ACCESS REPORT

STATE SIGNIFICANT DEVELOPMENT APPLICATION

**BLOCK 4N – CENTRAL PARK,
BROADWAY & ABERCROMBIE STREET,
CHIPPENDALE**

Prepared By Mark Relf
24th October 2014

External Pathway Links and Building Entrances (Parts D3.2 & D3.3 of the BCA)

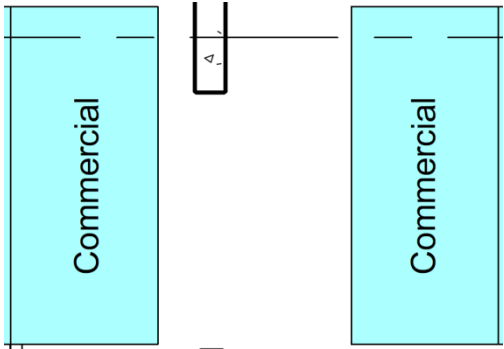
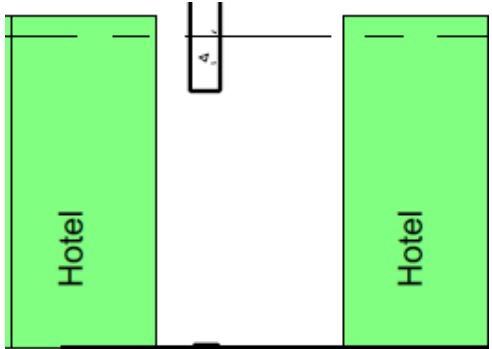
2. Hotel Access – The plans propose the principal hotel entrance shall provide an at-grade entry from the Broadway public domain footpath RL12.66 and intrasite accessways to access the hotel lobby @13.20, which ensures equitable and universal access to satisfy Part D3.2 of the BCA and DDA Premises Standards.	YES

3. The intrasite accessways also enable accessible approaches from a southerly direction @RL13.70 to the principal hotel lobby entrance @RL13.50 to satisfy Part D3.2 of the BCA and DDA Premises Standards.	YES

Parking (Part D3.5 of the BCA)

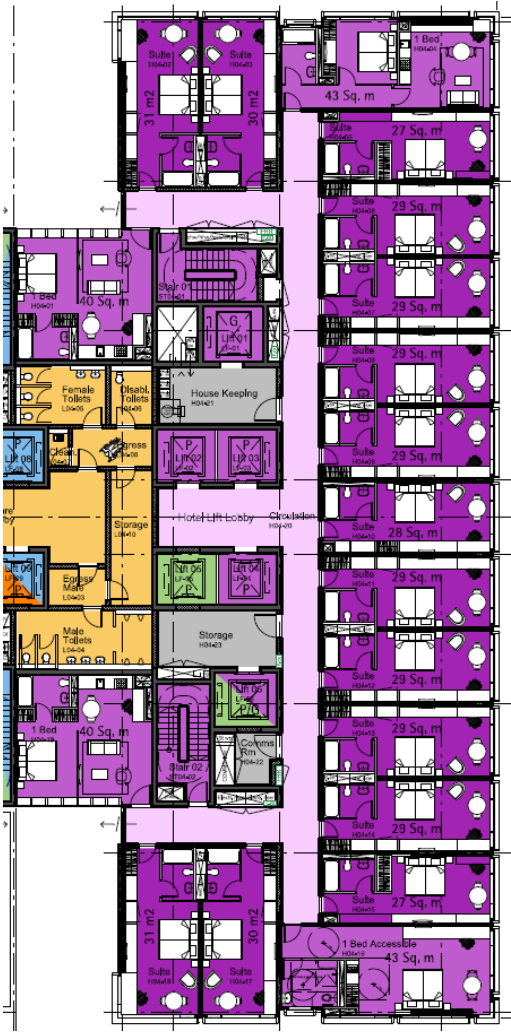
BCA / DDA Access Code Review	Complies
<p>12. The development propose 130 parking spaces which includes 56 spaces for the hotel, 5 retail spaces, 28 commercial spaces, 5 child care spaces, 32 residential parking and associated 4 service vehicles.</p> <p>13. With respect to accessibility the development can provide four (4) accessible spaces for hotel, commercial/retail and child care centre usage to satisfy Table D3.5 of the BCA.</p> <p>14. The four (4) spaces on levels 02 and 03 can provide 2400mm width adjoining a 2400mm shared area with 2500mm height headroom and level access to the lifts to comply with AS2890.6 to satisfy Part D3.5 of the BCA and DDA Premises Standards. While the columns vary from the bollard normally used to preserve the shared space the spaces will provide the same functional access.</p>	<p>YES</p> <p>YES</p>
 <p>2 potential spaces on B3</p>  <p>2 potential spaces on B2</p>	YES

<p>15. With respect to residential parking the basement will provide seven (7) accessible spaces for the seven (7) adaptable apartments, which is reported in section B of this report.</p>	See Section B

Internal Accessways (Part D3.3 of the BCA)

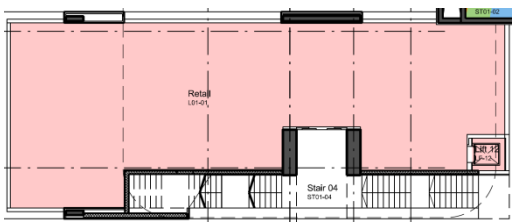
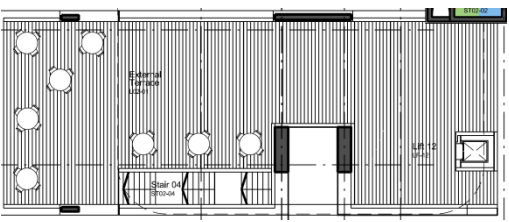
BCA / DDA Access Code Review	Complies
<p>Hotel – ground floor</p> <p>16. Within the ground floor hotel lobby there are two levels @RL13.20 and RL13.50 which are connected by ramp and stairway to ensure access to all areas including the reception, restaurant and sanitary facilities in accordance with AS1428.1 and Part D3.3 of the BCA and DDA Premises Standards.</p> <p>17. The lobby provides direct access to three (3) lifts to access the upper levels and basement parking to satisfy Table D3.1 and Part D3.3 of the BCA and DDA Premises Standards.</p> <p>18. The back-of-house commercial kitchen and associated store rooms are regarded areas exempt from “accessibility” requirements due to the particular use consistent with Part D3.4 of the BCA/DDA Premises Standards.</p> <p>19. Doors and Door Hardware - The construction documentation shall confirm</p>	<p>YES</p> <p>YES</p> <p>YES</p> <p>YES at</p>

Accessible Sanitary Facilities (Part F2.4 of the BCA)

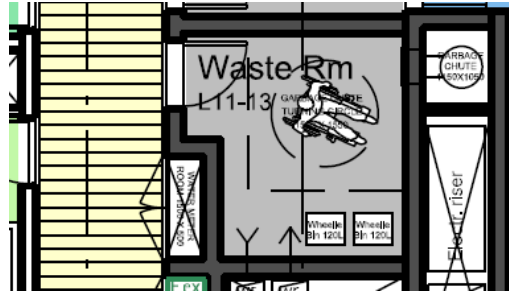
BCA / DDA Access Code Review	Complies
77. The plans illustrate communal sanitary facilities on all the relevant levels and areas and incorporate unisex accessible toilets on each level in accordance with AS1428.1, Part F2.4 of the BCA and DDA Premises Standards including the accessible hotel suites.	YES

78. Unisex wheelchair accessible sanitary facilities shall be detailed to comply AS1428.1, Part F2.4 of the BCA and DDA Premises Standards, including the installation of alternating left and right handed layouts in accessible hotel suites and other areas where two or more are provided.	YES at CC stage
<p>79. Male & Female Cubicles are required to Ambulant Accessible. - Cubicles are to be designed with an outward swing 750mm cubicle door with the internal area providing 900mm X 900mm minimum circulation space, with;</p> <ul style="list-style-type: none"> • 450 X 450 grabrails on both sides, • a toilet pan with a 460-480mm seat height and • a coat hook 1350-1500mm height; as specified by Clause 16 of AS1428.1 to satisfy Part F2.4 of the BCA. 	YES at CC stage
